ORIGINATION FORM

Proposed Revisions to a Standard Plans Index

Index Number: 455-031

Index Title: 30" SQUARE PRESTRESSED CONCRETE PILE -
HIGH MOMENT CAPACITY**Summary of the changes:**

INDEX
455-031

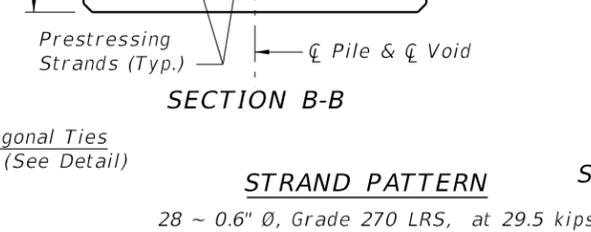
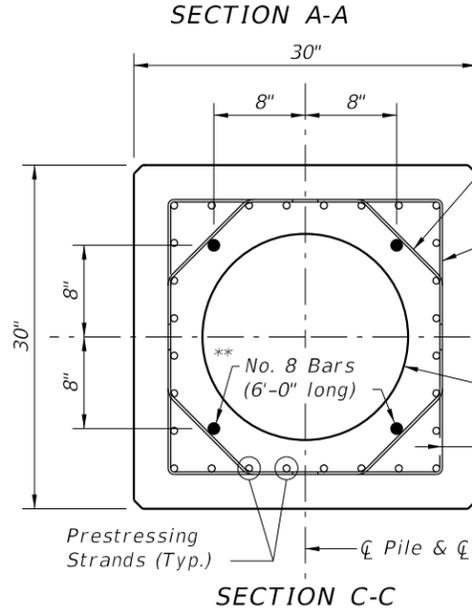
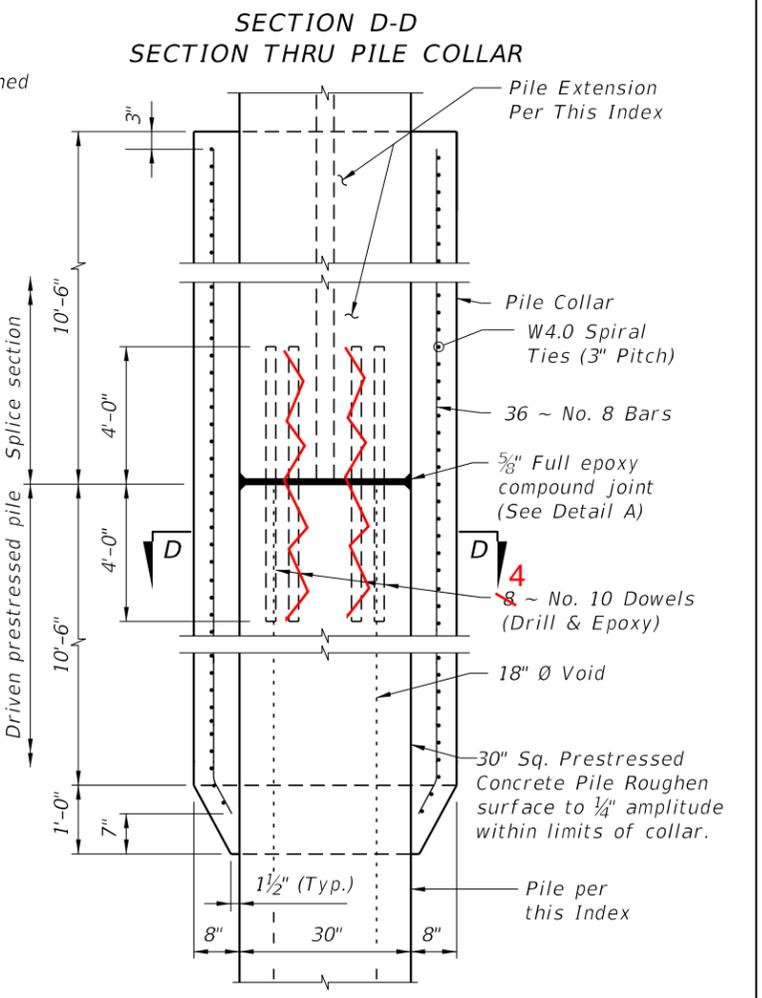
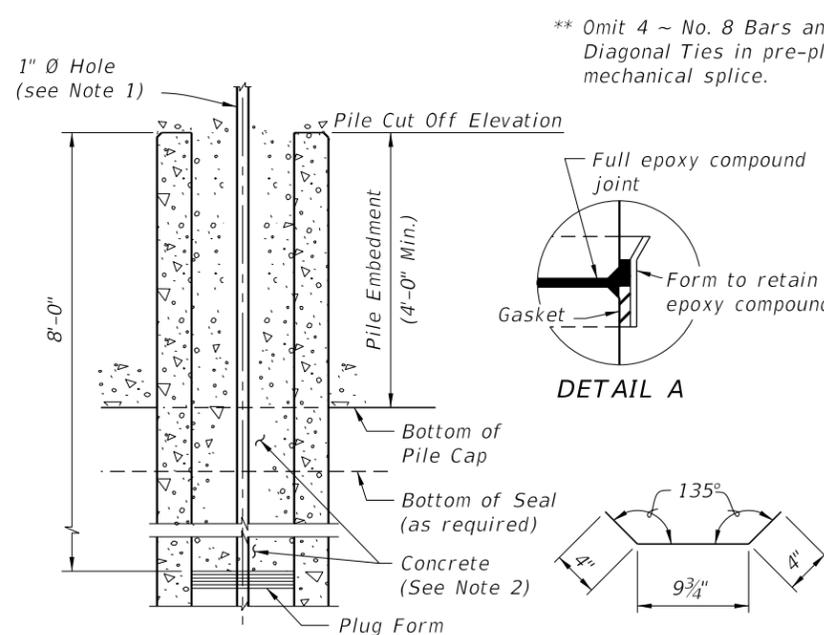
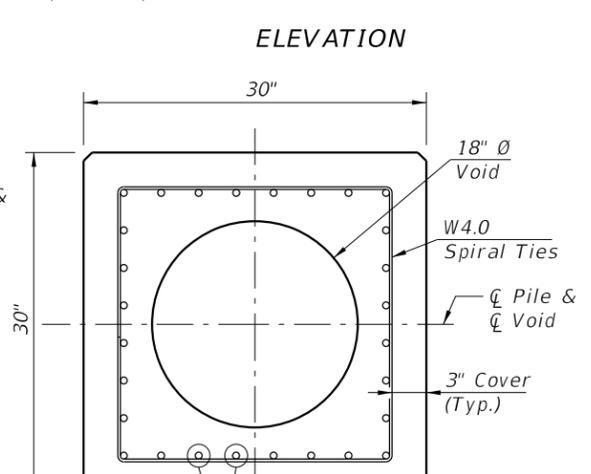
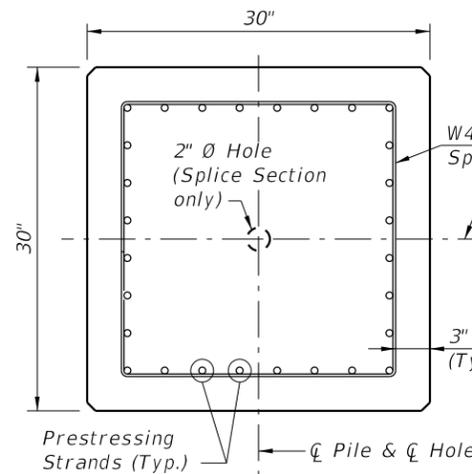
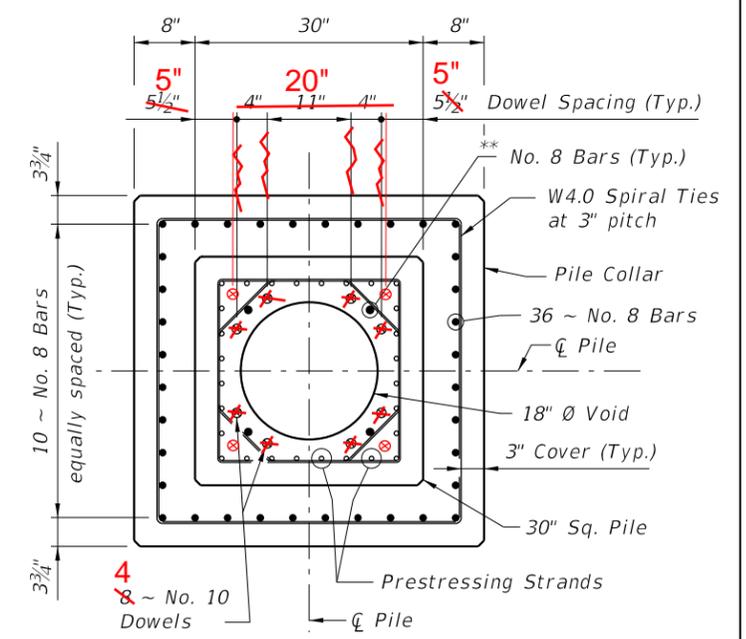
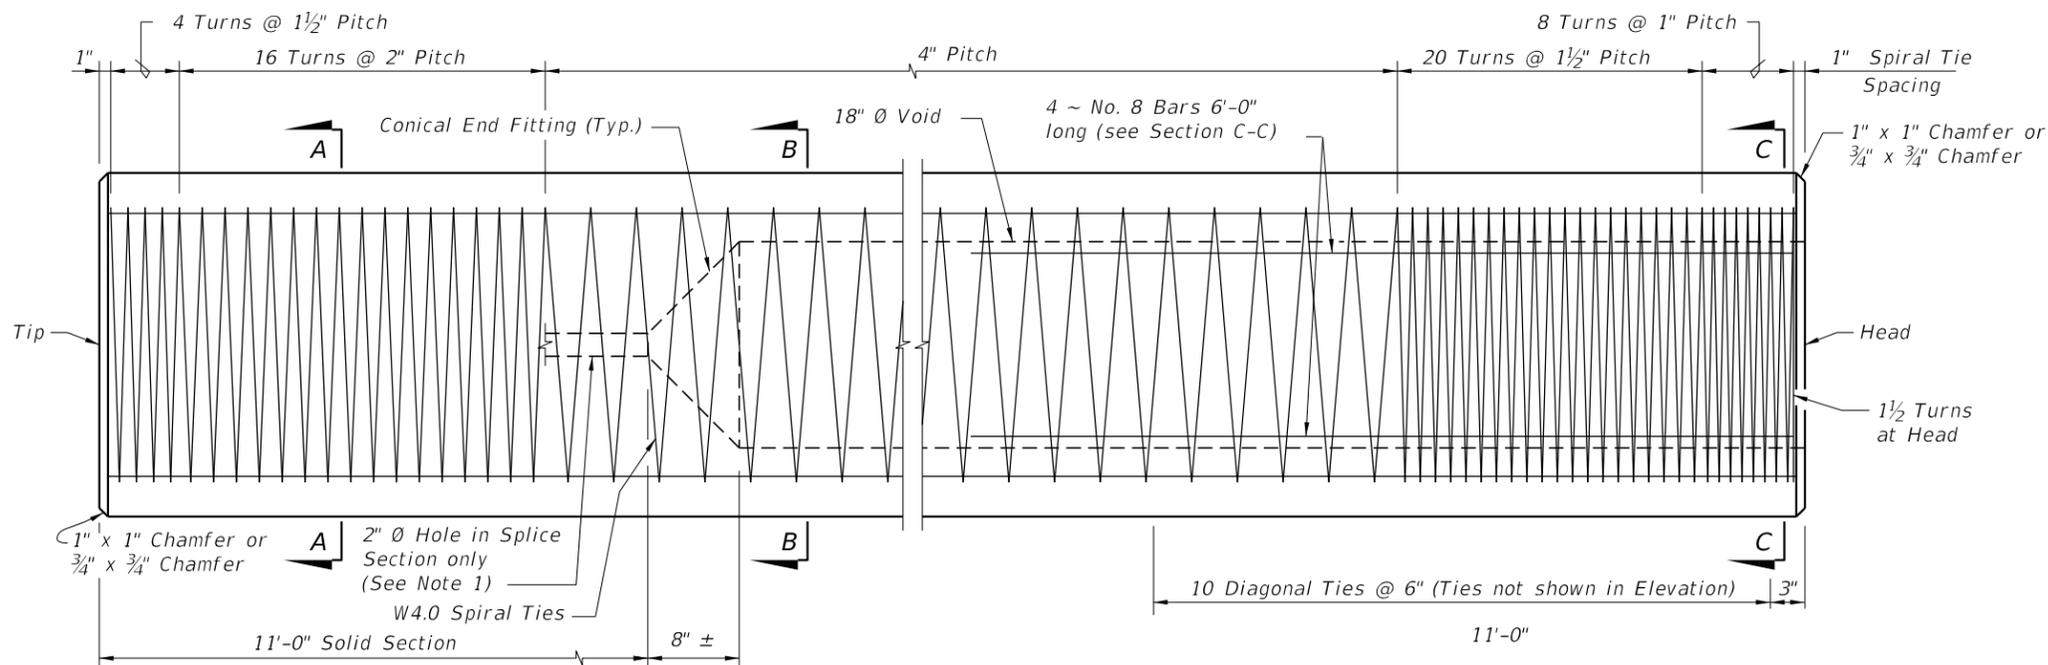
Sheet 1: Changed the location of the dowels; Deleted part of note 2 not allowing for corrugated galvanized metal pipe forms.

The location of drilled holes for the #10 dowels that are epoxied into the voided end for the splice connection are extremely close to the face of the void and will spall during drilling (1-3/4" drill bit).

These dowel bars should be moved further inside the pile wall, but the only place to avoid other reinforcing is inside the corner of the strand pattern (see the blue circle in the markup below). This would reduce the total number of dowel bars possible from 8 to 4, but this should be OK since almost all the moment capacity comes from the collar reinforcing (36~ #8 bars on the perimeter) recognized these extend lapped 10-feet either side of the splice joint while the #10 dowel bars only extend 4-feet and are temporary restraint and alignment while the exterior collar is constructed. -- Steve Nolan

For the metal pipe forms it was decided that the forms would create a corrosion risk and reduce the possible lifespan of the pile. Therefore, this allowance was removed.
